Electronic Pressure Relief Valve (EPRV) Delete & Fuel Rail Pressure Sensor Update

Model Years	Models
2018 - 2020	VAH/VHD/VN

EPRV Delete & FRPS Update

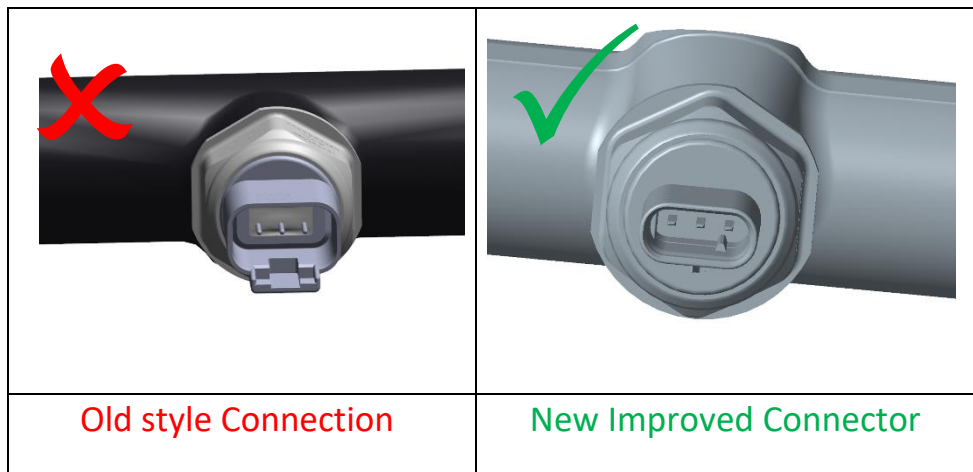
- 17. A product improvement has been made to the Fuel Rail Pressure Sensor (FRPS) and its wiring harness. A visual inspection of the FRPS electrical connector will indicate which sensor and wiring harness is on the vehicle.

18. Inspect the FRPS, if the Old Style Connector is found (Displayed above with red X), replace the sensor and wiring harness per Impact Instructions listed below. If the New Improved Connector is found, no farther action is needed and proceed to next step.
 - a. 2373-03-03-06 Pressure Sensor, Common Rail, Replacement, Valve Cover Removed
 - b. 2861-03-03-03 Wiring Harness, Injector, Replacement (Rear), Valve Cover Removed
19. Refer to IMPACT document ID: 2115-03-02-02 *Valve Cover, Replacement* for valve cover install procedure.
20. Using PTT Operation 1700-22-03-06 Program accessory kit: **85156014**
Note: Running this kit without removing the ePRV will result in adverse vehicle affects.
